# SAN FRANCISCO PLANNING DEPARTMENT

**DATE:** June 10, 2014  
**TO:** Sean Sullivan, JS Sullivan Development, LLC  
**FROM:** Joy Navarrete, Planning Department  
**RE:** PPA Case No. 2014.0562U for 469 Eddy Street

## Preliminary Project Assessment

*Date:* June 10, 2014  
*Case No.:* 2014.0562U  
*Project Address:* 469 Eddy Street  
*Block/Lot:* 0337/014A  
*Zoning:* RC-4 (Residential – Commercial, High Density) Use District  
North of Market Residential Special Use District  
80-T Height and Bulk District  
*Area Plan:* None  
*Project Sponsor:* Sean Sullivan, JS Sullivan Development, LLC  
415-206-1758  
*Staff Contact:* Kansai Uchida – 415-575-9048  
[kansai.uchida@sfgov.org](mailto:kansai.uchida@sfgov.org)

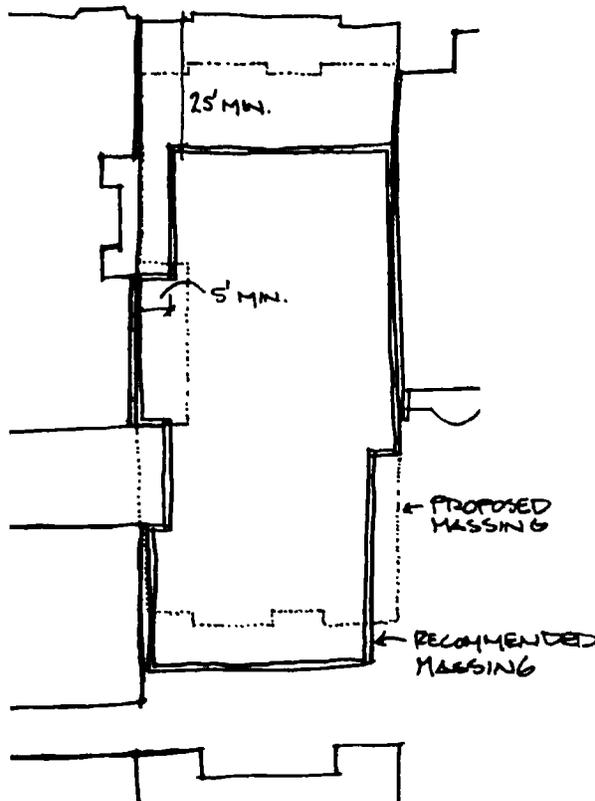
1. **Site Design, Open Space, and Massing.** The Planning Department recommends adjusting the massing of the project 1) to create a better relationship between it and the existing building as well as other buildings on the street frontage, and 2) to better respond to and accommodate the relationships between the building massing and open spaces at the rear, light well, and setbacks

The Planning Department recommends better integrating and preserving the existing historic resource to be more fundamentally a part of the project by setting the addition back a minimum 25'. The interior of the new structure should appropriately reuse or relate to the retained portion of the existing resource.

Re-configure the plan to minimize units that do not meet the exposure requirements.

Match the adjacent light well on the west side of the property to bring the west side of the property in a minimum of 5' to match the adjacent lightwell.

Additionally, the project should create a lightwell or notch at the back open notch of the westside property and could also create a reciprocal notch at the open space to the east. The Planning Department would support the rear wall moving back as long as exposure requirements are met either there or with the adjacent open space on the east side.

This plan diagram should help clarify the intent.

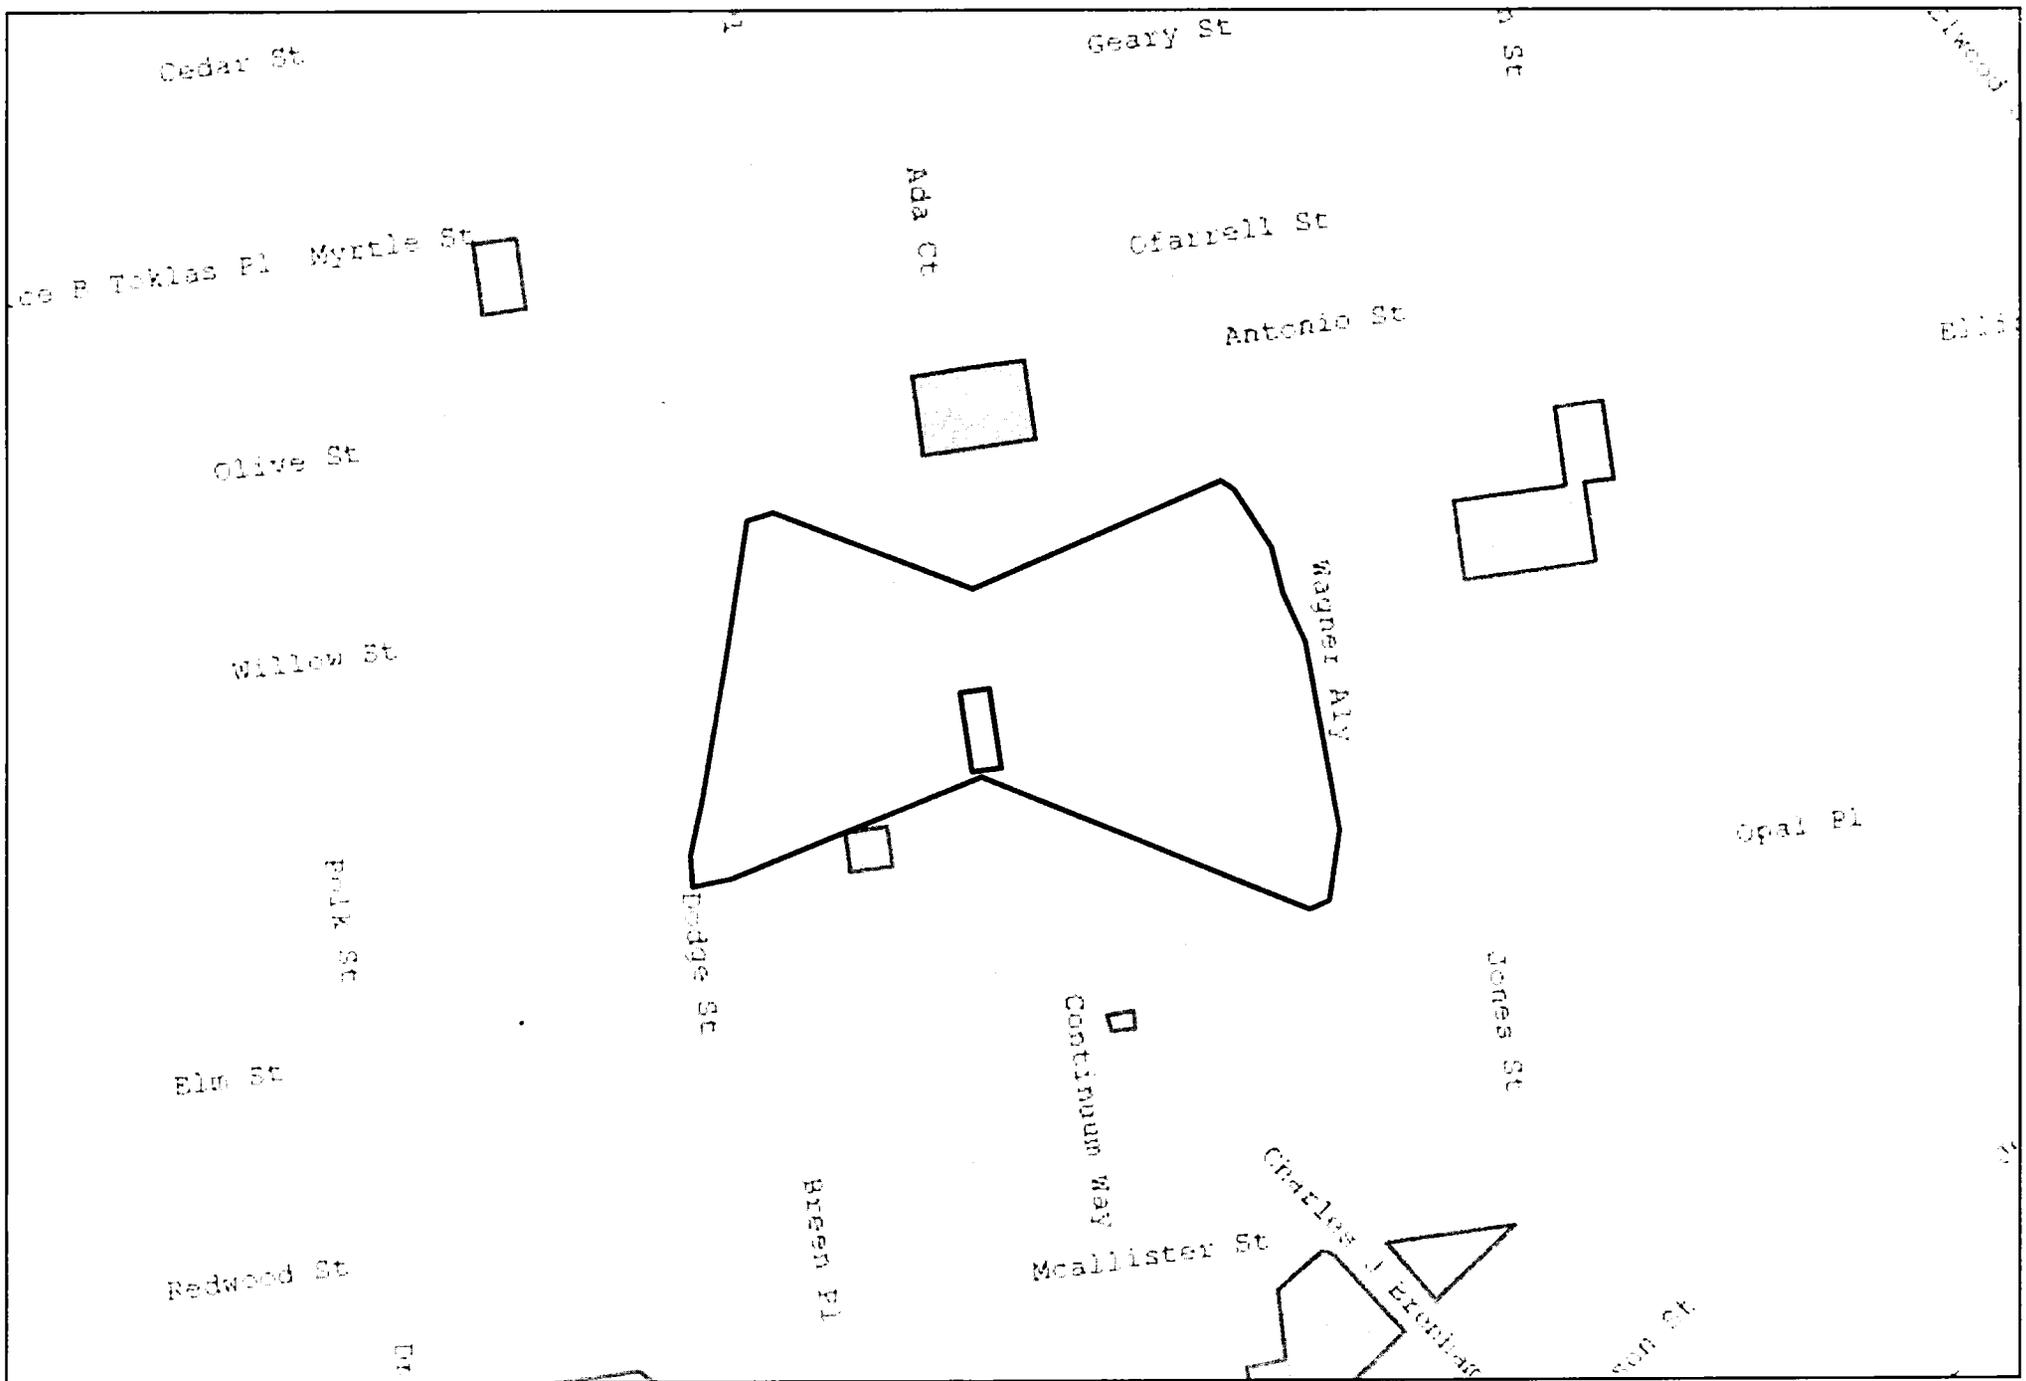
- a. **Composition and Style:** Existing buildings share a common tripartite vertical composition with defining architectural elements. The proposed addition design should respect the solid-to-void ratios of buildings within the District and incorporate compositional elements to break up the façade, including punched openings and introducing a strong horizontal element defining the top of the addition.

- b. **Massing:** Currently, the proposed design shows the addition setback 10 feet from the face of the existing façade with five stories rising above the existing two-story building and the existing second floor of the façade acting as a screen for patios for new residential units. Although buildings within the District range in height, the proposed massing overwhelms the existing building and inappropriately reuses the existing building façade. The setback and massing of the addition should more appropriately address the size and scale of the existing building. The Planning Department recommends setting the addition back 25-35 feet and reducing the overall height of the addition. Further, the front portion of the existing building should be retained as usable interior space at both the first and second floors.

- c. **Materials:** It is unclear what all the proposed building materials are. Please call out all materials, texture, and color of finishes including window and storefront system finishes proposed for the addition and rehabilitation of the existing façade. The addition should draw from the masonry material and texture typical of the existing building and Uptown Tenderloin Historic District.

- d. **Bay Windows:** The proposed arrangement of balconies does not complement the existing building and surrounding buildings, which have some regularity in pattern and are mostly symmetrical in layout. The proposed balconies appear to lack regularity in that they are located in alternating bays. The balconies and bay windows, if proposed, should be better integrated with a more complementary composition that draws on the patterns of bays and fire escapes on adjacent buildings within the District and that does not overwhelm the existing building.
